RE: Data Request #2 - Certificate of Public Convenience and Necessity for the Riverside Transmission Reliability Project – Application No. A.15-04-013

REQUEST FOR ADDITIONAL DATA: DATA NEEDS #2 FOR THE RIVERSIDE TRANSMISSION RELIABILITY PROJECT - APPLICATION (A. 15-04-013)

Exhibit A: Underground Transmission Line Route (Map 1)

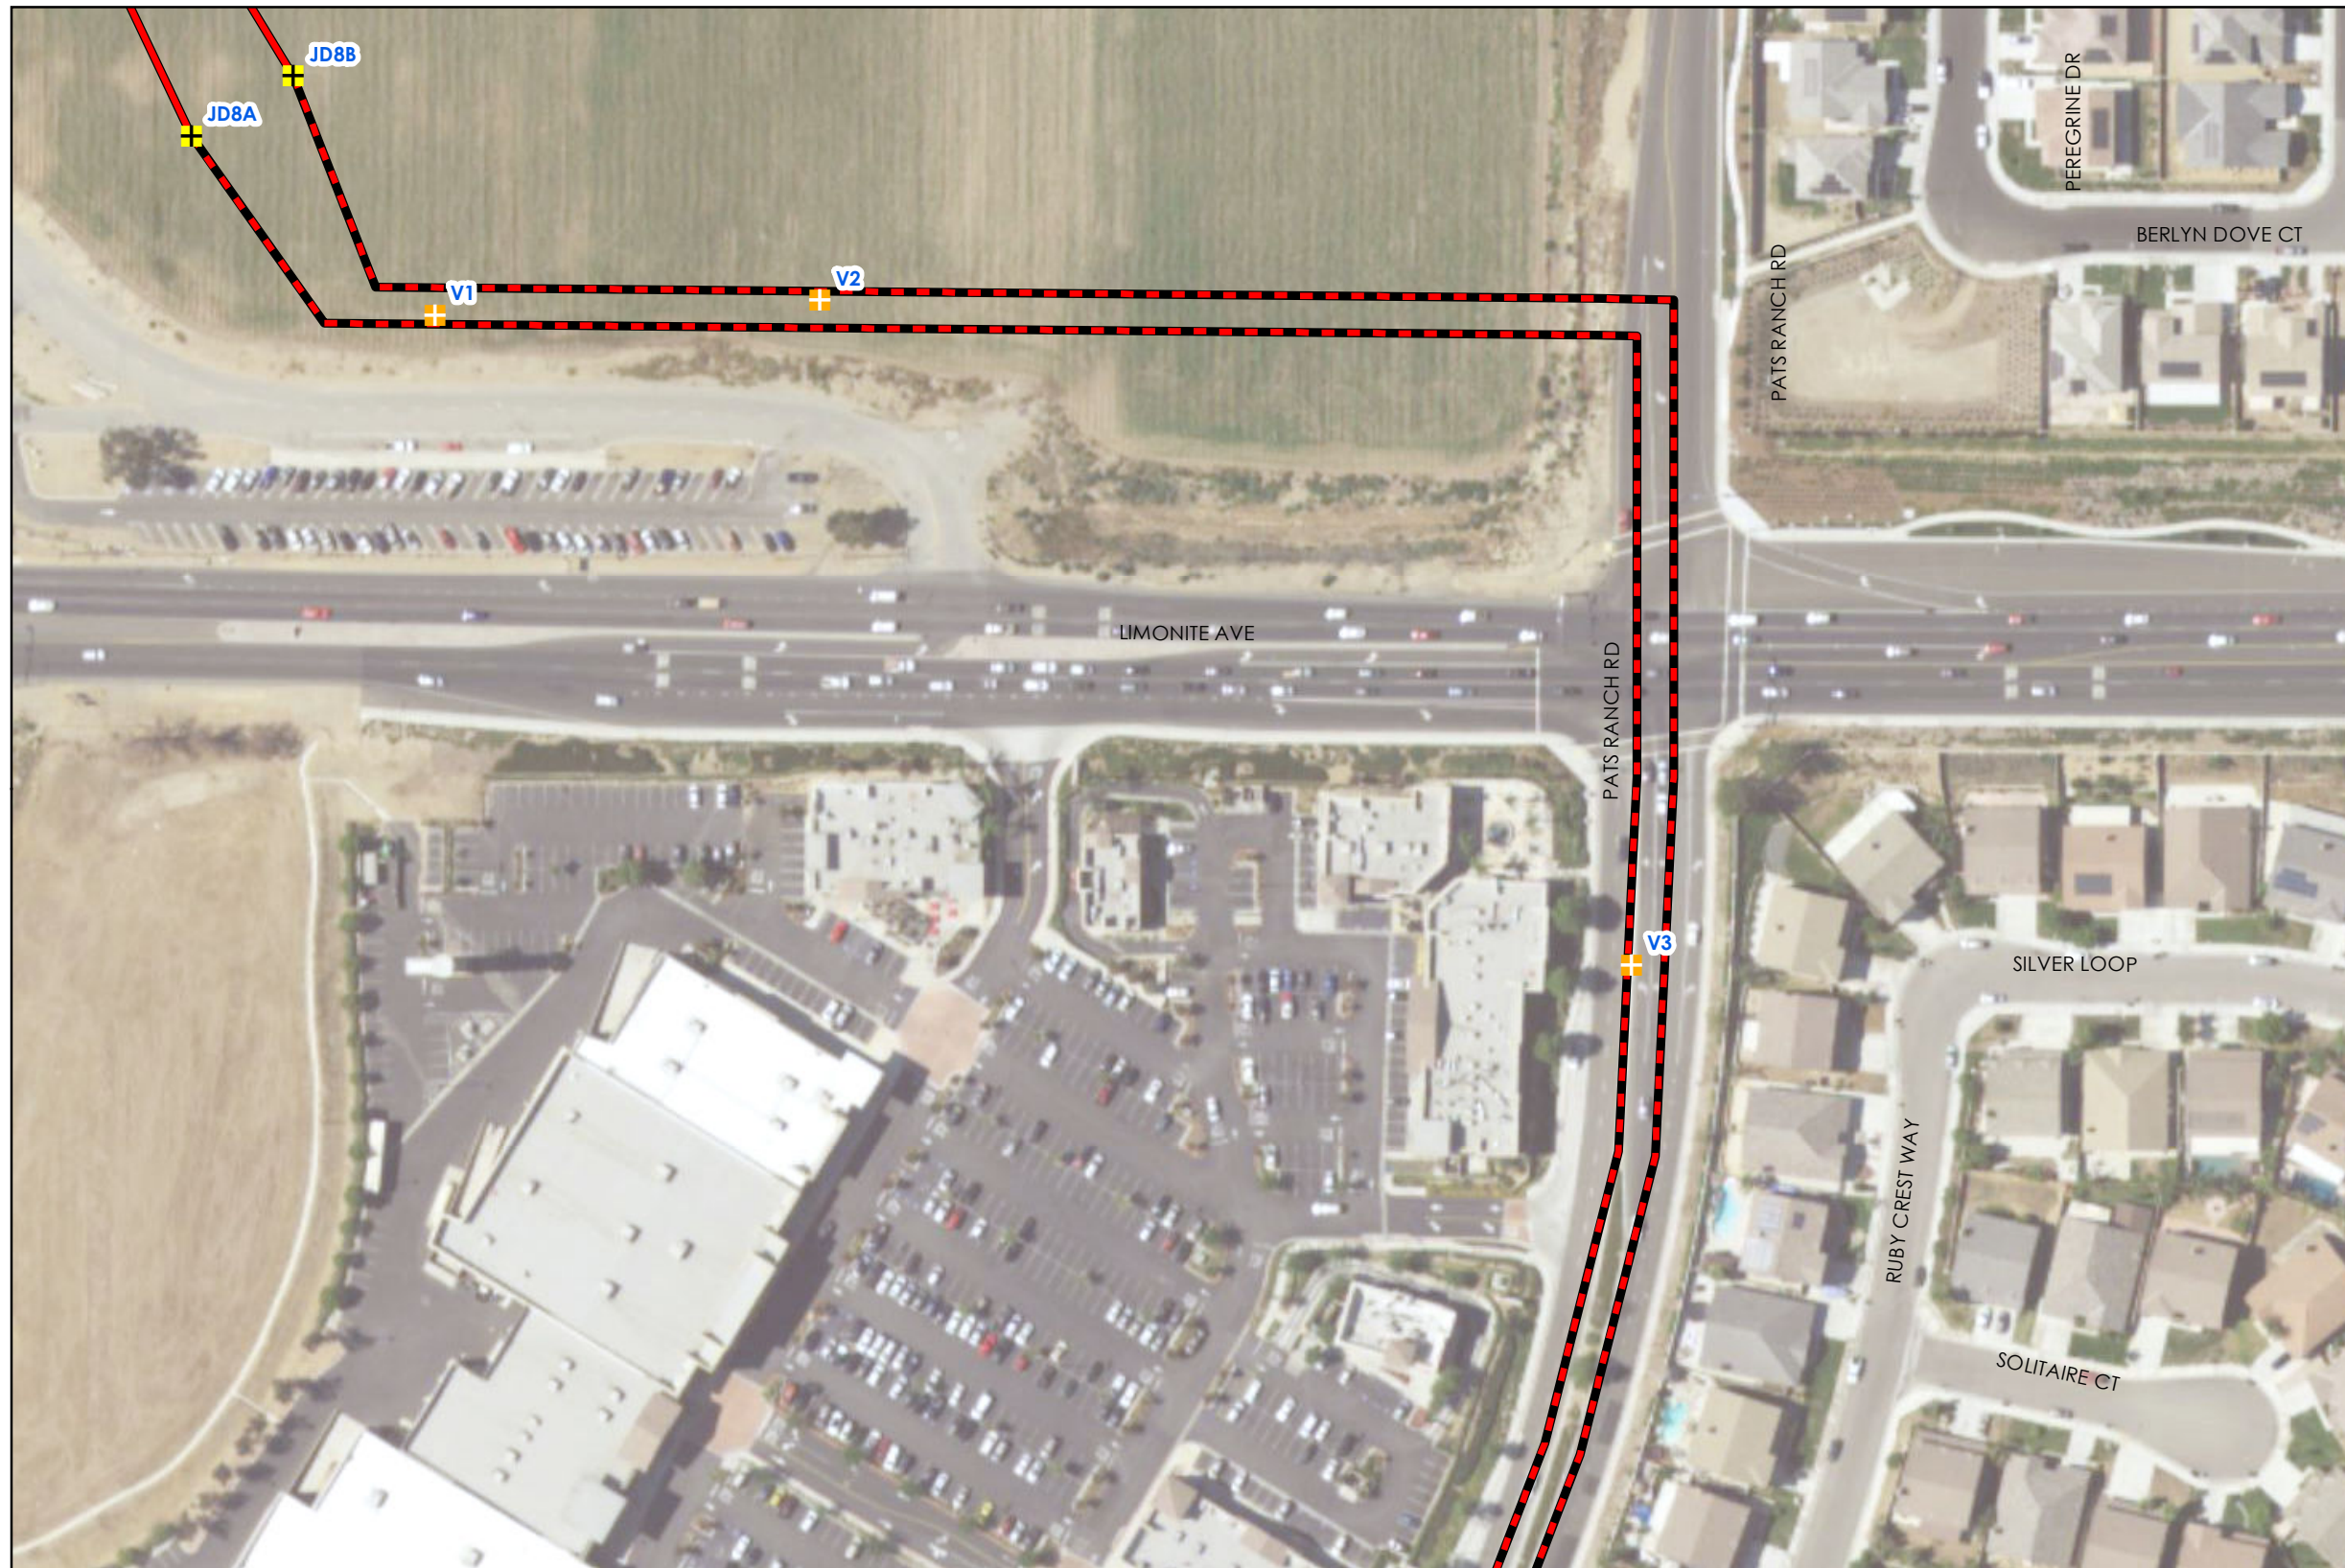
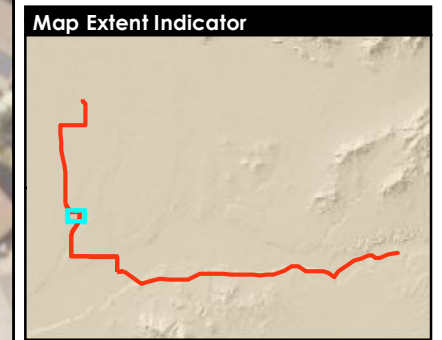
| Number | Data Need |
|--------|--|
| PD-9 | <p>Verify that the 90-degree-angle bends shown in Exhibit A (attached) on Pats Ranch Road north of Limonite and on 68th Street at the Goose Creek Golf Course are technically feasible in the tight radius shown and with the proposed vault structure locations as presented.</p> |

| Table 1: SCE Riverside Transmission Reliability Project Application 15-04-013 Data Needs #2 | |
|--|--|
| | Provide GIS and PDF maps indicating any further refinements if these bends or vault structure locations do not accurately represent an approximation of the underground alignment. |
